# PREVOST

## Warranty Bulletin

96-07

Date: **April 1996**  
Section: **07**  
Subject: **WIRING HARNESS MODIFICATIONS - W/T TRANSMISSION**  
Application:

FIGURE 1: VIEWED FROM DRIVER'S SIDE

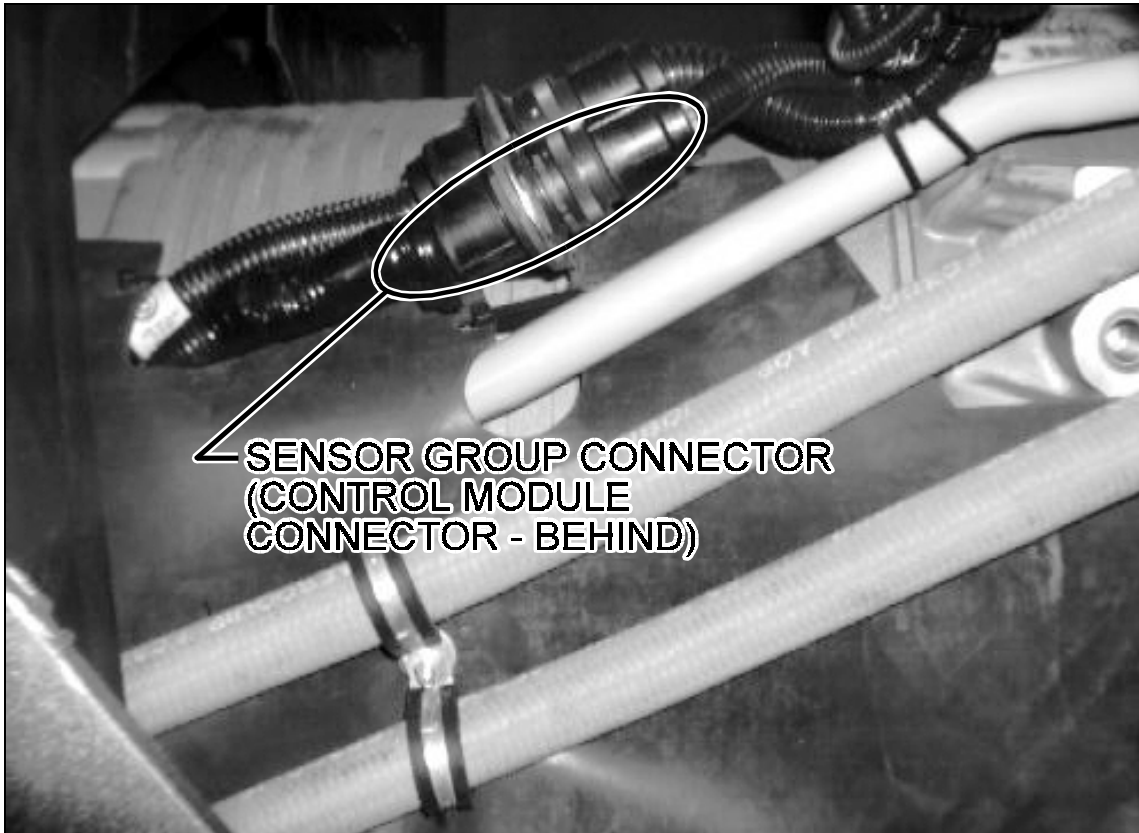
An error has been found in the manufacturing of two connectors on World transmission wiring harness. Wire 140 on both connectors is installed in position "A" and should be in position "L". This error does not cause any malfunction or problems other than the fact that when harness #064237 is replaced, a code 22-15 gets logged into the queue. To remedy this situation, proceed as follows.

1. Access transmission (driver's side) from behind tag axle and locate wiring harness. (Fig. 1)
2. Disjoin harness connector for sensor group (Fig. 1).
3. Using the proper tool, extract wire 140 from position "A" and reinsert into position "L" for both male and female connectors.
4. Rejoin connector.
